Brookhaven National Laboratory Plant Engineering - E&CS Division Engineering Change Notice Form

PROJECT: CCWF II

ECN Title: Knock-Out Wall Detail

ECN No. 15

302F TYP KNOCK-OUT WALL DETAIL

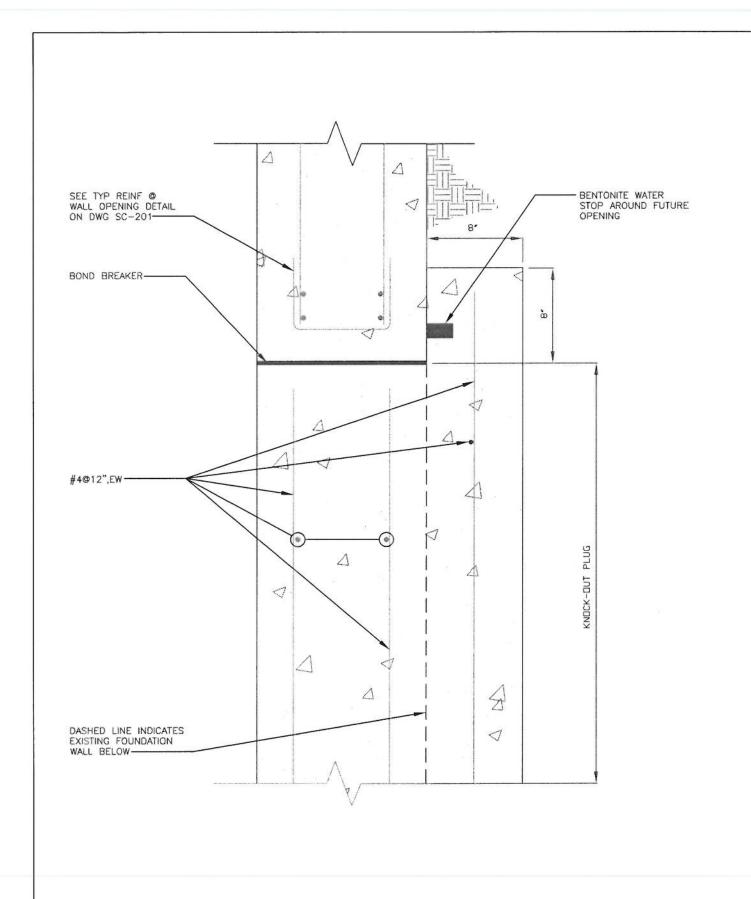
Affected Documents: SC-301, SC-302				
Requested Change (Attach sketch if applicable): The Knock-Out Panel for the future opening was modified to				
extend past the foundation wall by 8" and there will be a Bentonite waterstop all the way around the				
	opening. The Knock-Out Panel will be poured into the penetration as well as the 8 inches that exter past the wall.			
Requested by:	: A. Raphael		Date:	12/1/09
Resolution:	Approved. See attached Sketches.			
1000				
Approvals:	A/E or Proj. Eng.: B. Kimble	₹	Date:	12/1/09
	Project Coordinator: A. Raphael		Date:	12/1/09
	Manager:		Date:	Name State of Sections
Contractor shall take the following action:				
	☐ Await change order from P&PM			
	Proceed with change as described	1		
Provide cost proposal for change as described				
Distribution:	E. W. Howell	Giffels		
	E&U	MPO		
	O&M	DOE		
	NSLS II	ECN File
